# Technical Service Bulletin

<b>Topic</b>	Squeaking noise from the footwell whilst steering / manoeuvring at low speed
<b>Market area</b>	Australia E04 Bentley rest Asia and Australia (6E04),China 796 VW Import Comp. Ltd (Vico), Beijing (6796),Germany E02 Bentley rest Europe (6E02),Japan E03 Bentley Japan (6E03),Korea, (South) E08 Bentley South Korea (6E08),United Arab Emirates E06 Bentley Middle East and Africa (6E06),United Kingdom E01 Bentley UK (6E01),United States E05 Bentley USA and rest America (6E05)
<b>Brand</b>	Bentley
<b>Transaction No.</b>	2073002/2
<b>Level</b>	EH
<b>Status</b>	Released for publishing
<b>Release date</b>	Feb 21, 2025

Figure 4

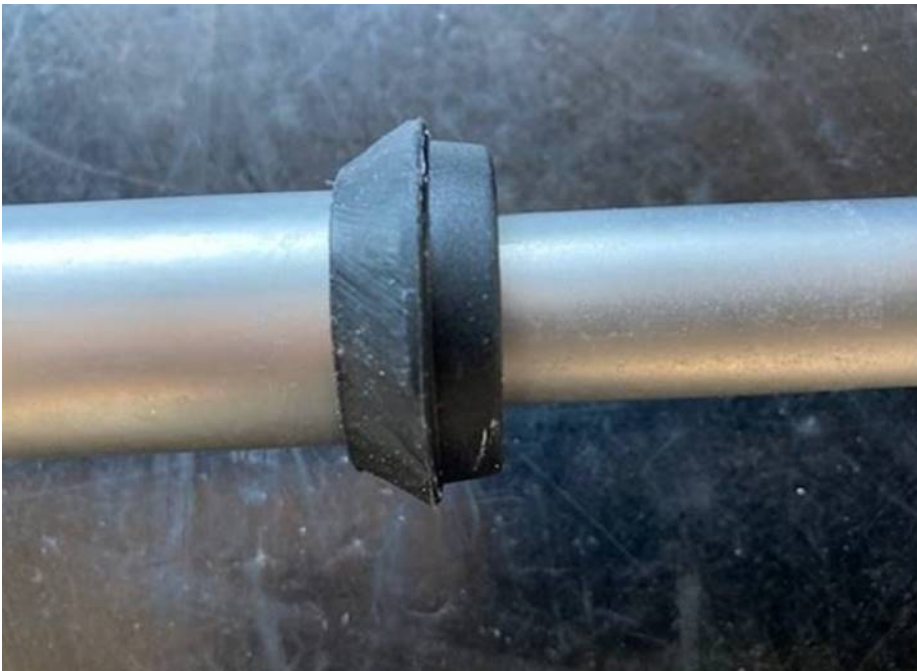
2) Using a suitable knife cut (shape) the intermediate steering shaft rubber collar on the sleeve side at a 45° angle (Figure 3) until at the condition is as shown in Figure 4

**⚠ WARNING**  
**Warning: Do Not slide the rubber collar on the shaft**

**Only the sealing boot may be moved on the shaft**
